REGIONAL REVIEW FINDING

Name of Proposal: Star Metals DRI 3695 Submitting Local Government: City of Atlanta Date Opened: August 4, 2022 Date Closed: August 28, 2022

ATLDOT Comments (#3695 Star Metals District Preliminary Report)

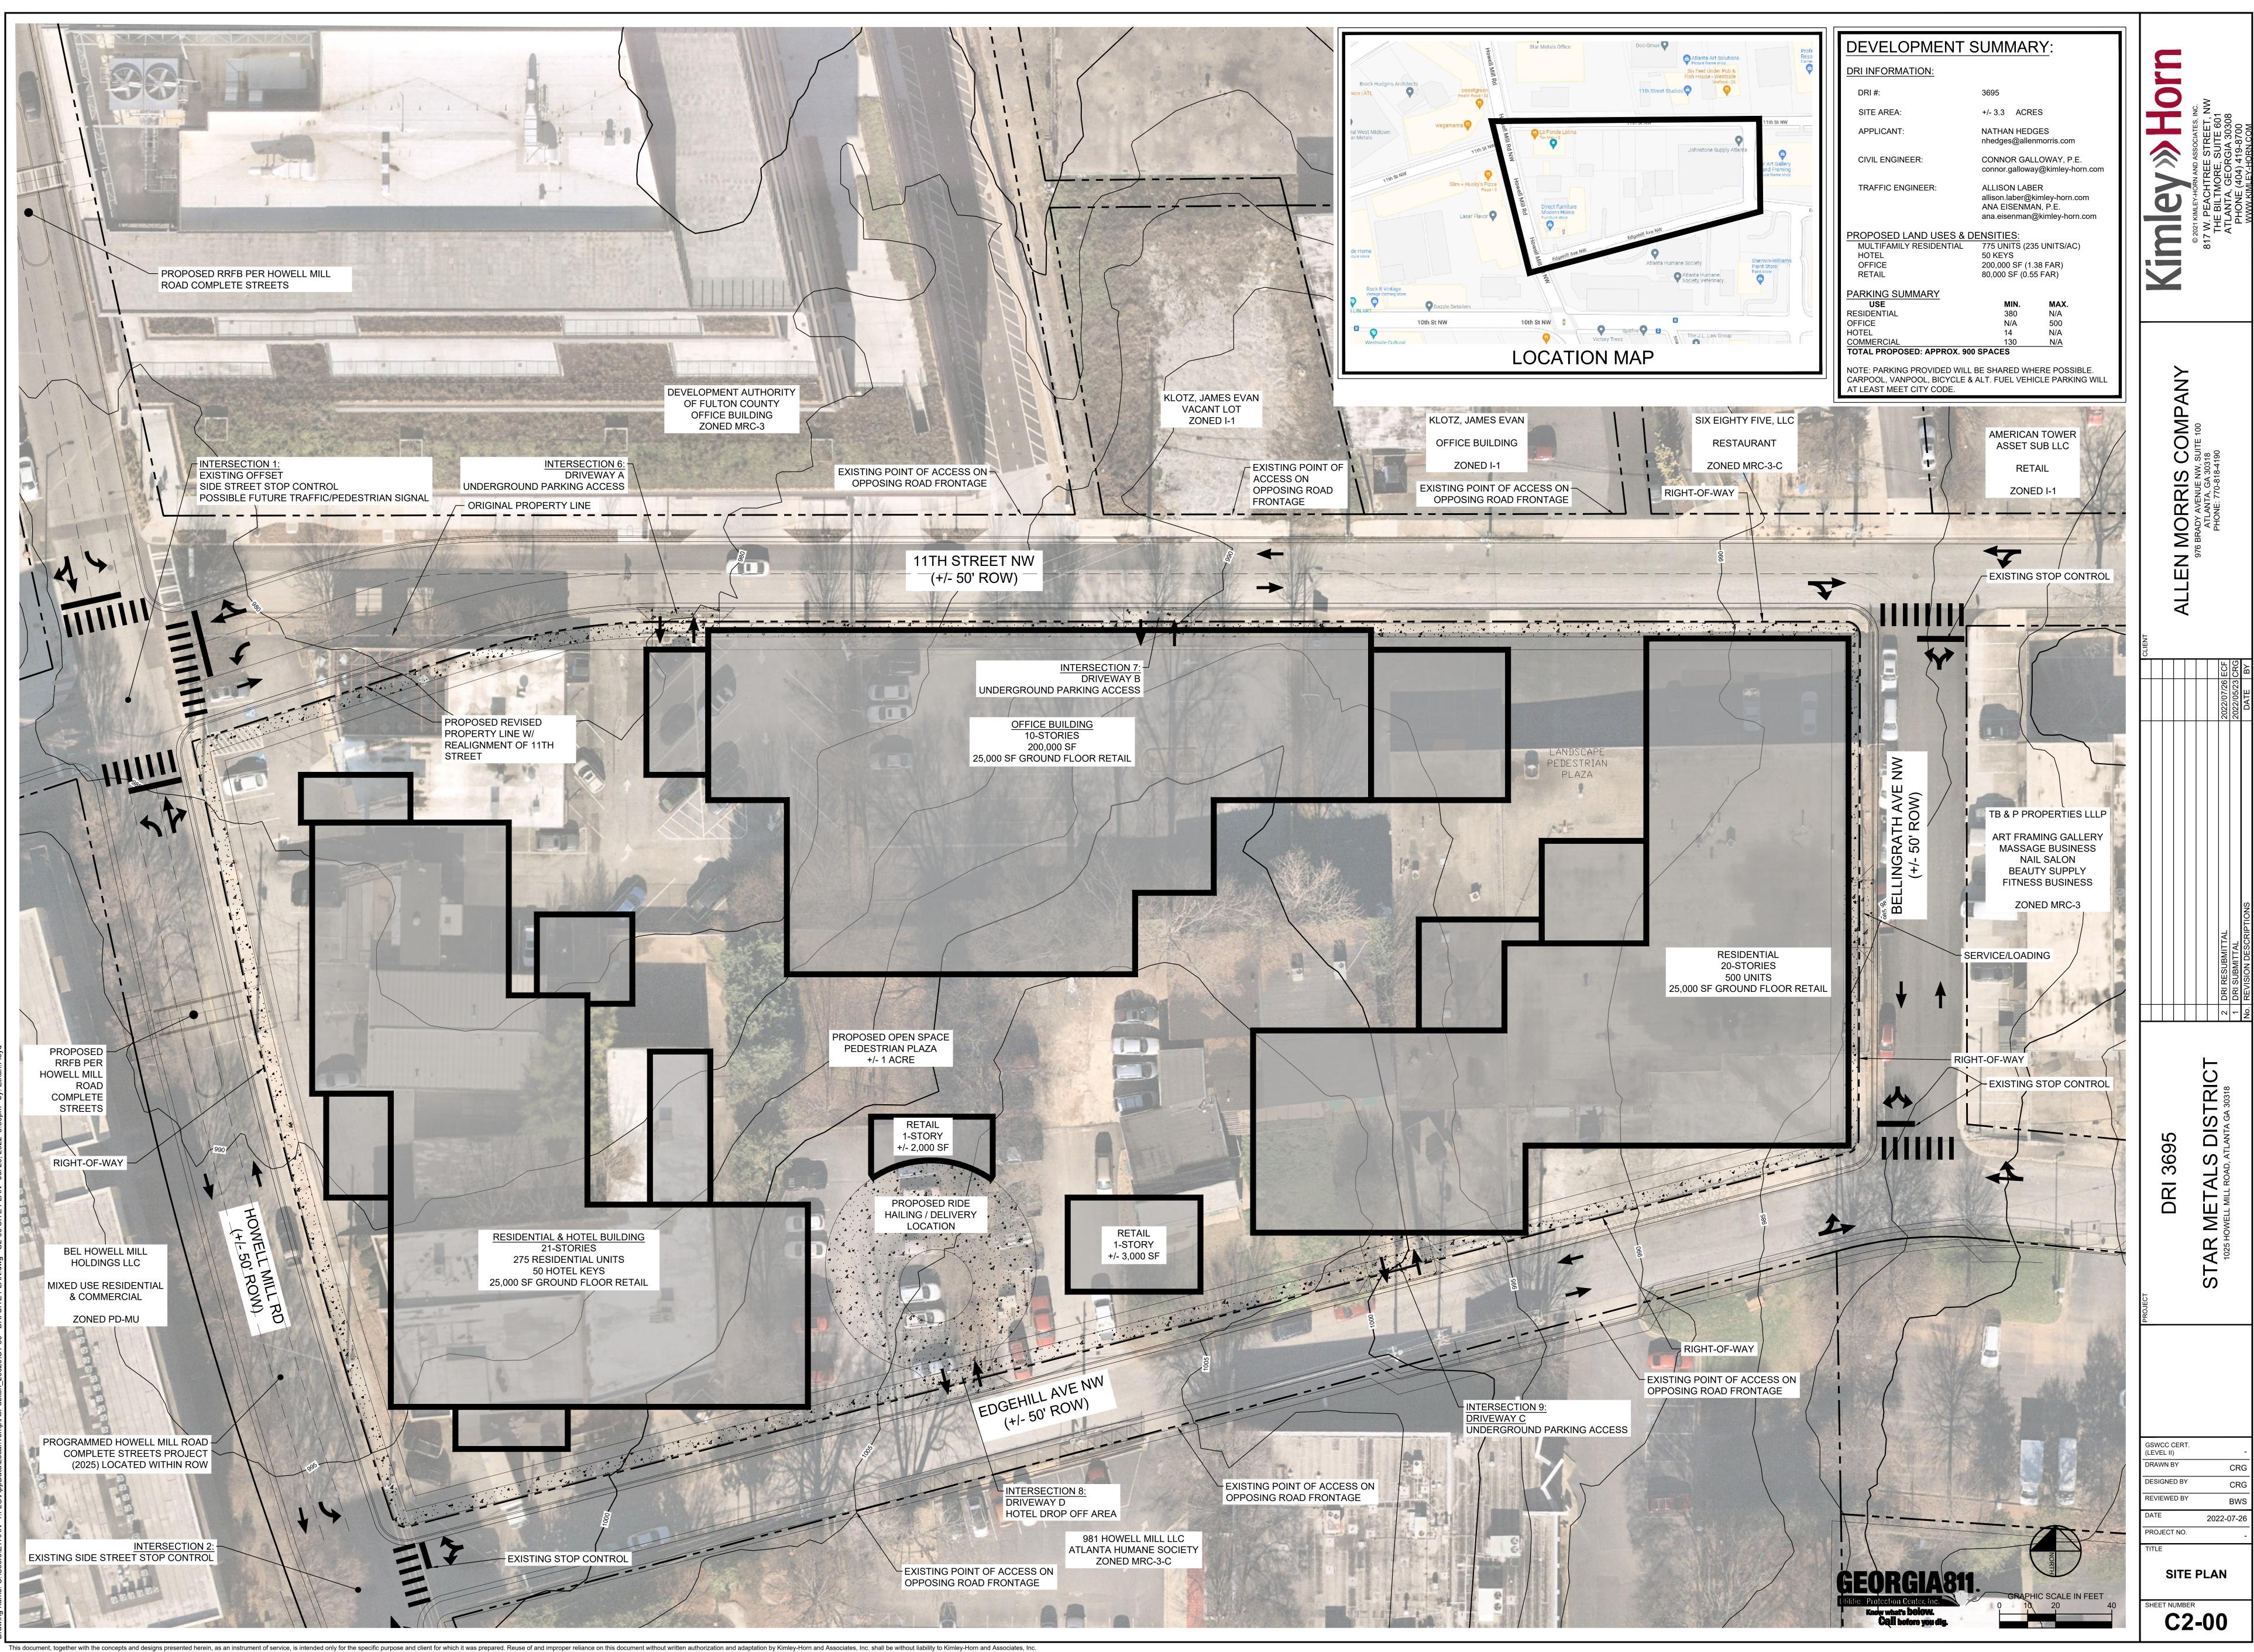
- Recommend a 3-way stop and crosswalk at 11th street and Bellingrath Ave to provide pedestrian connectivity. Especially since a residential tower is slated for that corner.

- Consolidate or relocate Driveways A and B, and C and D min spacing from intersection is 100' as well as 200' min between driveways.
 - Maximum permitted number of driveway curb cuts for each development, subject to the provisions of section 16-25.002(3):

- i.Developments with only one street frontage, which is less than 300 feet in length: One.
 - ii.Developments with only one street frontage, which is greater than or equal to 300 feet in length: Two, separated by a minimum distance of 200 linear feet.

- iii.Developments with two street frontages: Two. One per street frontage or two curb cuts located on the lower classified street per Map Attachment B (Type 1 being the highest classification).

- iv.Developments with three or more street frontages: One per street frontage. No more than one curb cut may be located on the highest classified street per Map Attachment
 B.

- Developer will be required to install the recommended traffic signal at 11th St and Howell Mill Rd to obtain permit approvals from City of Atlanta. While the no-build conditions are projected to be LOS F, the development worsens the LOS F delay by 70% in the AM and 130% in the PM peak. Please note to GRTA to include this condition in the NOD.

- With installation of the traffic signal at 11th Street, the 4th leg crosswalk should be stripped west of intersection.
- Coordinate with ATLDOT project manager for THe Howell Mill Complete Streets Project (ATLDOT #1007), which is slated to start construction in early 2023, to align roadway improvements.
 Particularly, given the shifting/re-alignment of 11th Street intersection, should the proposed RRFB at the mid-block crossing be shifted further south?
